Proposal: The applicant is requesting approval to partition a 2.6-acre parcel into three parcels of approximately 19,893 square feet net, 19,545 square feet net, and 72,974 square feet with access from Aztec Loop and Conser Road.

Based on the above findings of fact, and the conditions of approval, the proposed project satisfies the applicable criteria and staff approves the Partition Application No. PA 21-03, Zuhlke Partition, pursuant to the conditions of approval listed below.

ZUHLKE PARTITION
3091 CONSER ROAD

EXISTING CONDITIONS

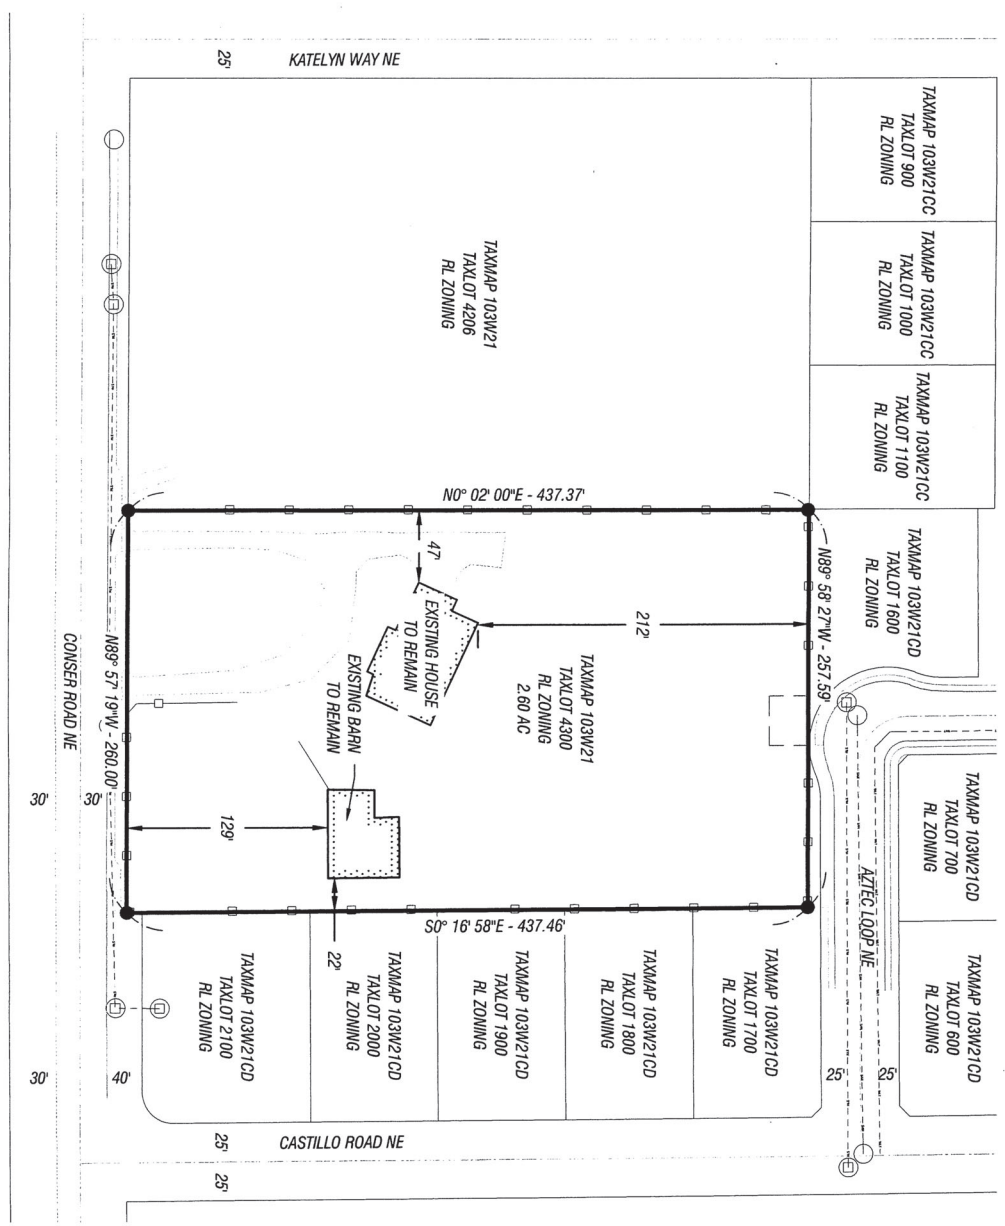
CONDITION OF APPROVAL: The final plat shall include a no-build and access easement between parcels (lots) 2 and 3 on the map to reserve a future right-of-way of 50 feet (or as approved by the City Engineer).

ANALYSIS: The project proposes three parcels. Parcel 2 and 3 are proposed to be about 150 feet deep and about 128 feet wide; parcel 1 is proposed to be about 262 feet deep and about 260 feet wide. These meet the lot to width ratio requirements.

Parcels 2 and 3 do not have the 40 feet of frontage required by 4.02.030.3; however, the Code does allow for access by private easement if 40 feet of frontage is not possible due to shape of the parcel. The property not having frontage on Aztec Loop means that 40 feet of frontage is not possible.
